PLANNING COMMISSION

5. PUBLIC HEARING - CONDITIONAL REZONING APPLICATION (File Number CR JPCR2016-002) – Proposed IHOP Restaurant and Retail, East side of Rochester, North of Big Beaver (1033 Urbancrest, 3130 Rochester, 3132-3142 Rochester), Section 23, From R-1E (One Family Residential) District to GB (General Business) District

6. PRELIMINARY SITE PLAN REVIEW (File Number SP JPLN2016-0027) – Proposed Troy City Center (Fidelity Investments), Northeast Corner of Big Beaver and Crooks (888 W. Big Beaver), Section 21, Currently Zoned BB (Big Beaver) District

Conditional Rezoning, Special Use and Site Plan Analysis
For
City of Troy, Michigan

PROPOSED SITE PLAN

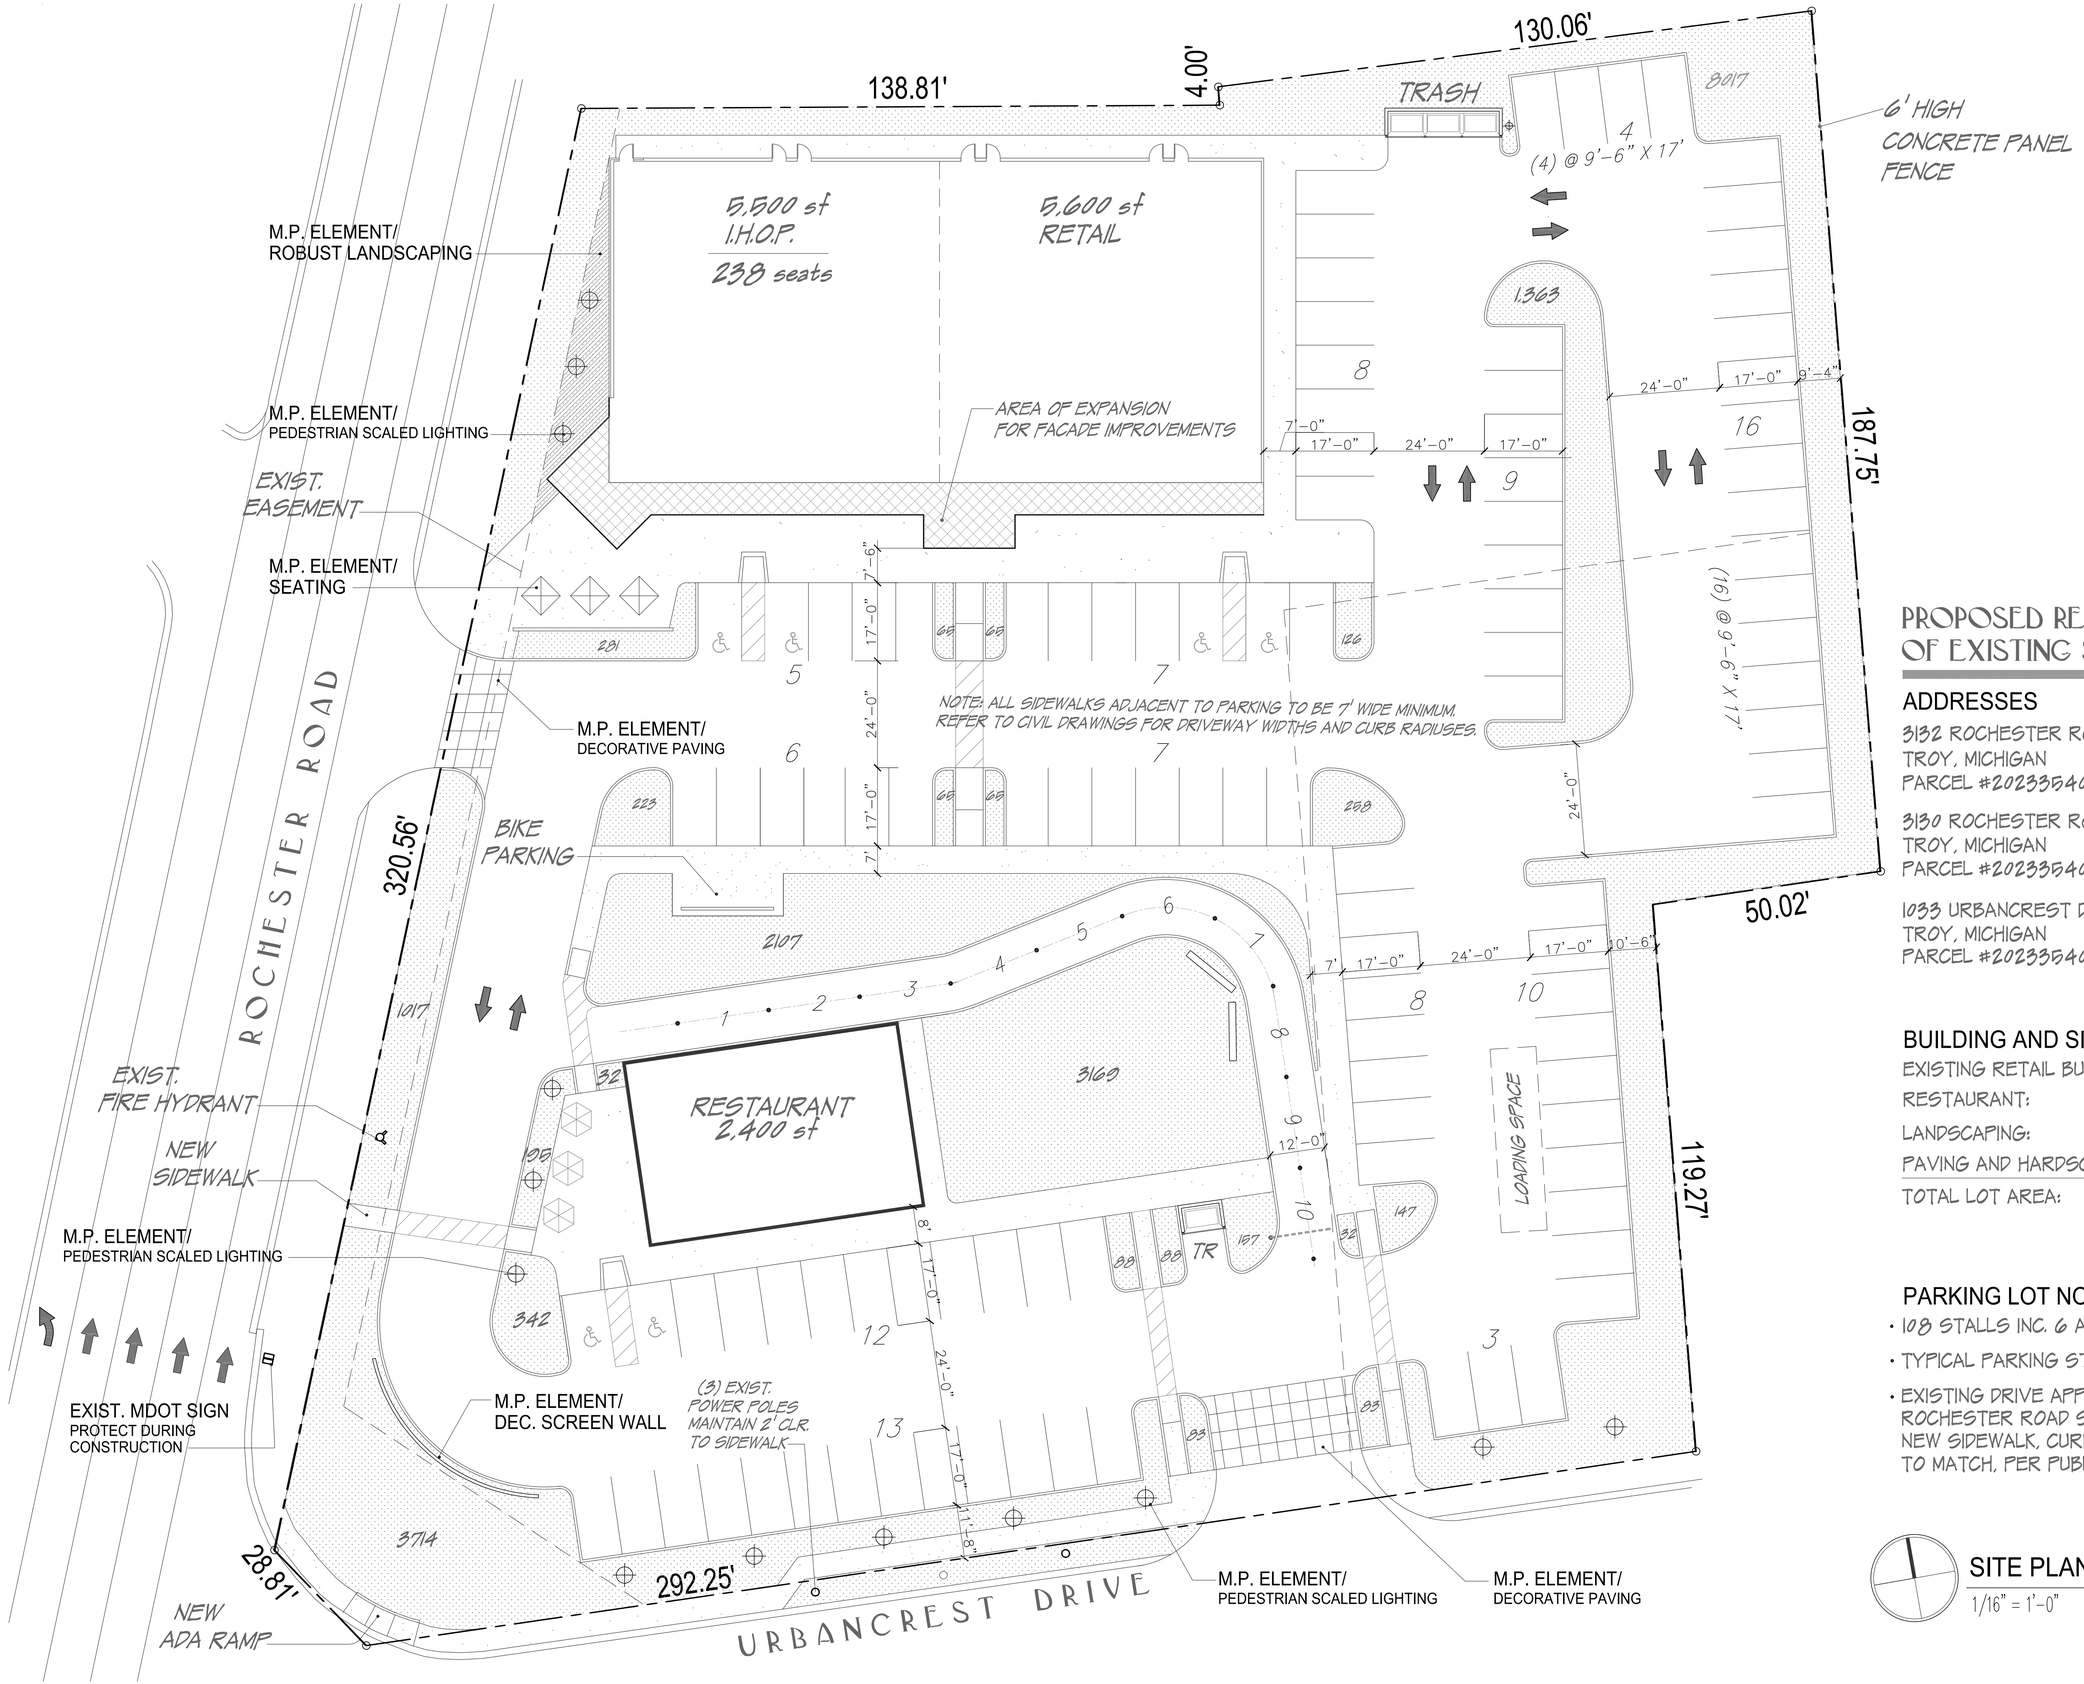
As previously mentioned, there is a watermain easement running along the east side of Rochester Road. This easement shall be depicted on the site plan.

A total of one-hundred and eight (108) parking spaces are provided. The applicant is 67 spaces deficient of the required 175 spaces. As set forth in Section 13.06.F, the Planning Commission may grant a parking deviation. Such deviation shall only be granted if the Planning Commission determines that a sufficient number of parking spaces is provided to accommodate the specific characteristics of the use in question. The applicant shall submit a parking study with adequate detail and information to assist the Planning Commission in determining the appropriateness of the request. The Planning Commission may attach conditions.

Items to be Addressed: *Submit a parking study with adequate detail and information to assist the Planning Commission in determining the appropriateness of the request.*

sheet no: LS-1 of 3

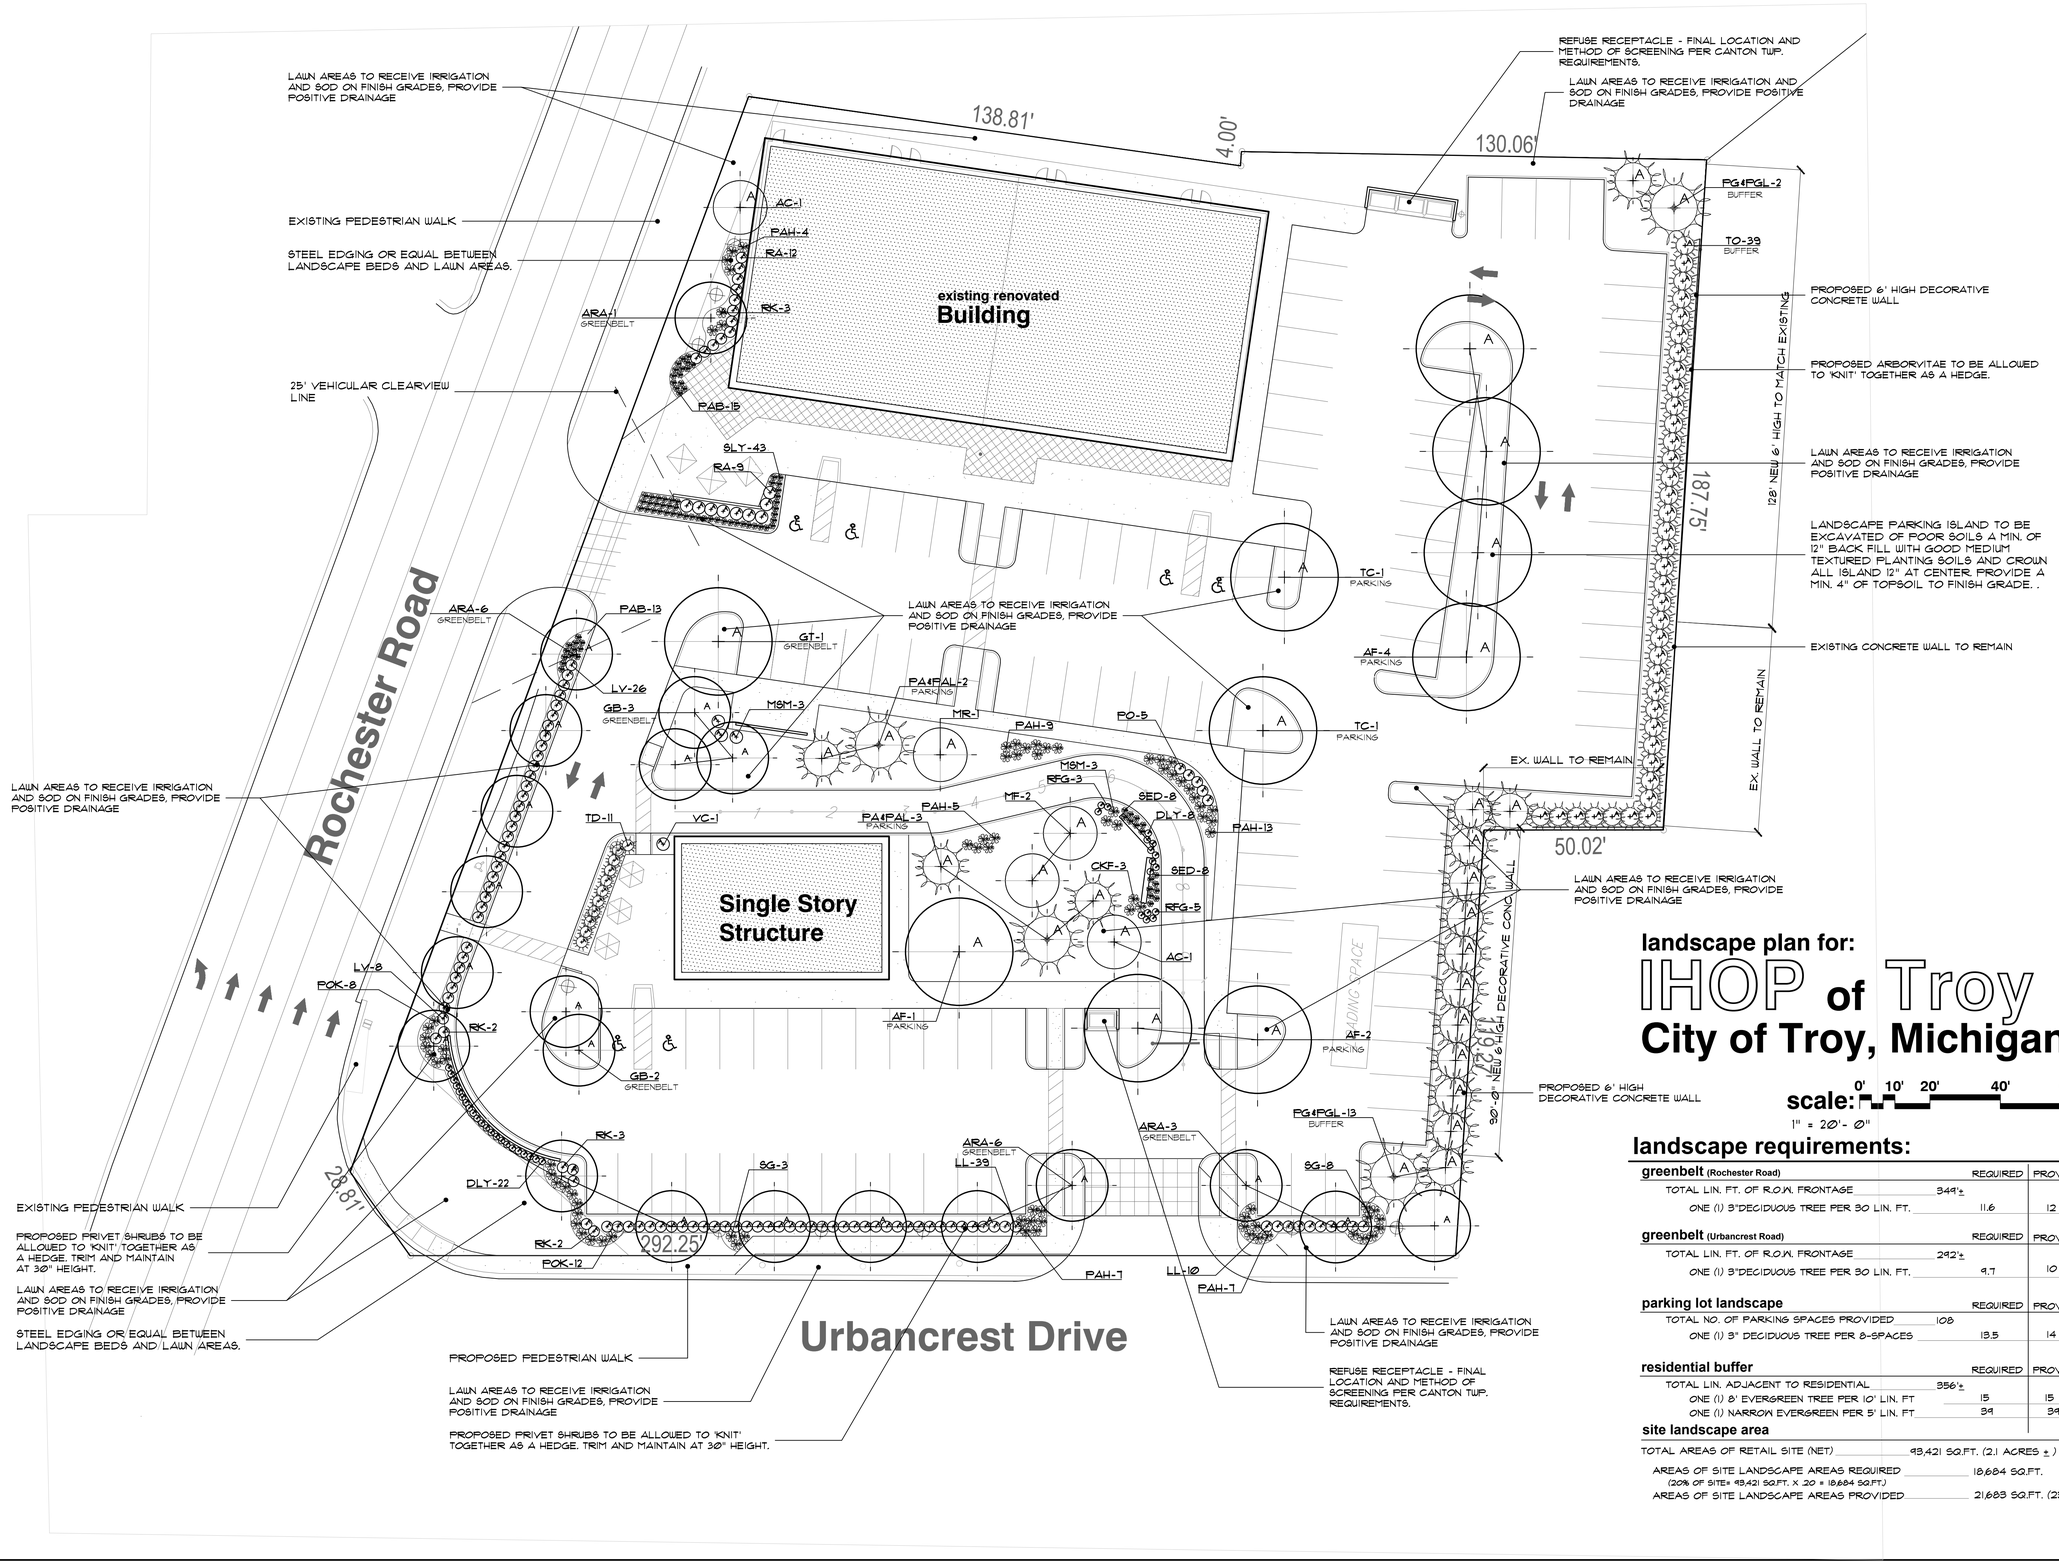
Trash Enclosure: Trash enclosures are proposed to the east of each of the buildings. Notes on Sheet LS-1 state that, *"final location and method of screening per Canton Township requirements."* These notes shall be modified to refer to Troy's requirements. Additionally, trash enclosure details/elevations shall be provided.

Items to be Addressed: *1) Provide 23 inches of additional trees above the minimum landscaping to account for tree mitigation; 2). Provide details/elevation of proposed wall along property line and at corner of Rochester and Urbancrest; 3) Modify trash enclosure notes to reflect the City of Troy's requirements; and 4) Provide details/elevations of proposed trash enclosures.*

EXTERIOR ELEVATIONS

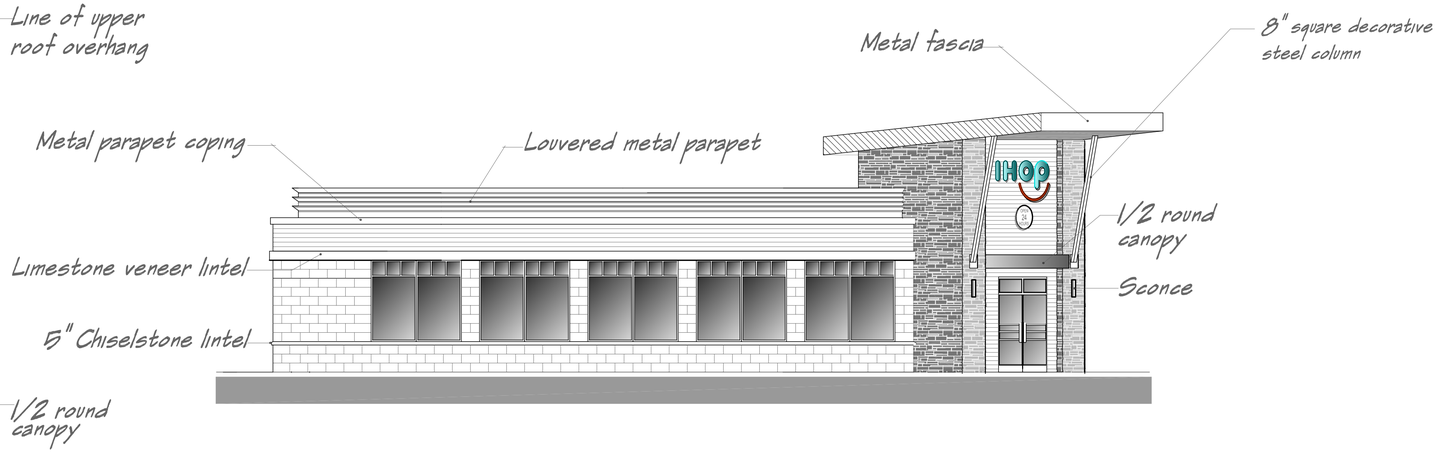
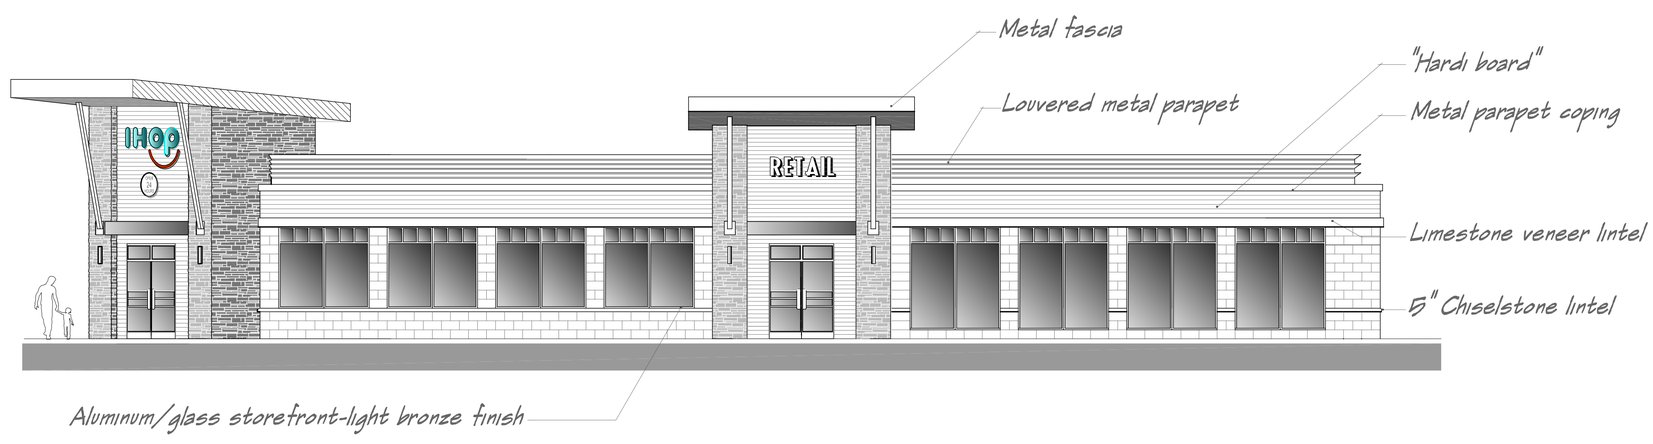
Floor plans/elevations have been provided for the proposed IHOP/retail building, but not for the drive-through building. The tenant of the drive-through building has not been determined. If permitted by the Planning Commission, the applicant could provide elevations for Planning Commission approval in the future once a final tenant for the drive-through building is determined.

Items to be Addressed: *If permitted by the Planning Commission, the applicant could provide elevations for Planning Commission approval in the future once a final tenant for the drive-through building is determined.*
